Interactive comment on “Future extreme precipitation intensities based on historic events” by Iris Manola et al.

Iris Manola et al.

Received and published: 24 November 2017

Fig. 1.

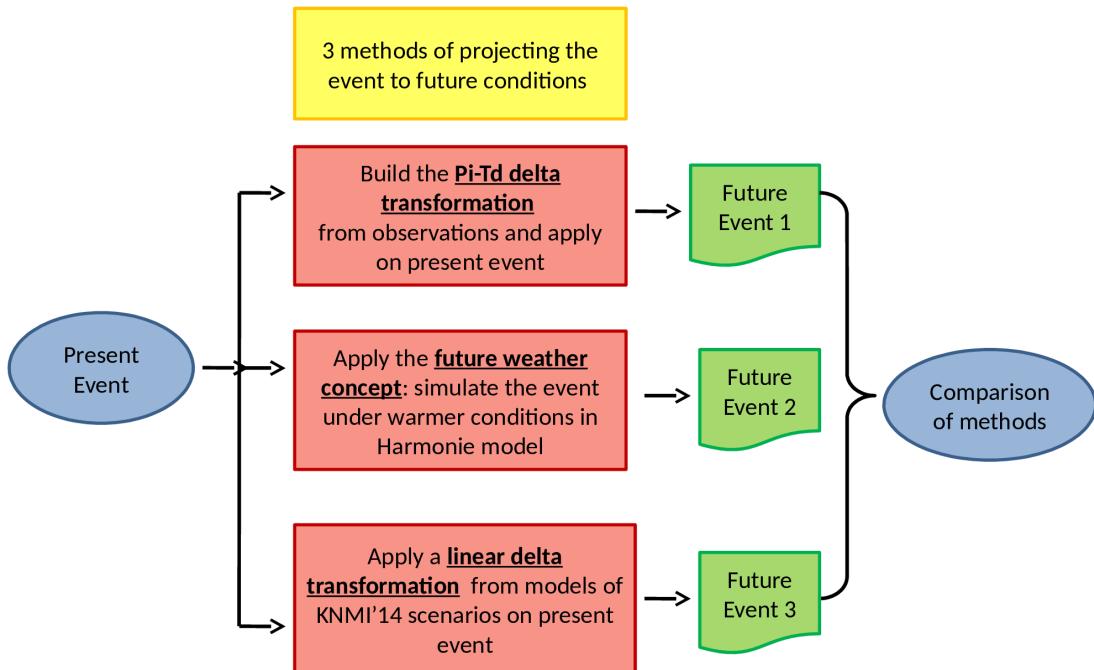
@ It is better to write the method name in each box in Fig.1.

To further clarify the names and uses of the 3 different methods the names, as suggested by the reviewer, will be mentioned in the flowchart as seen in the Figure 1, attached below.
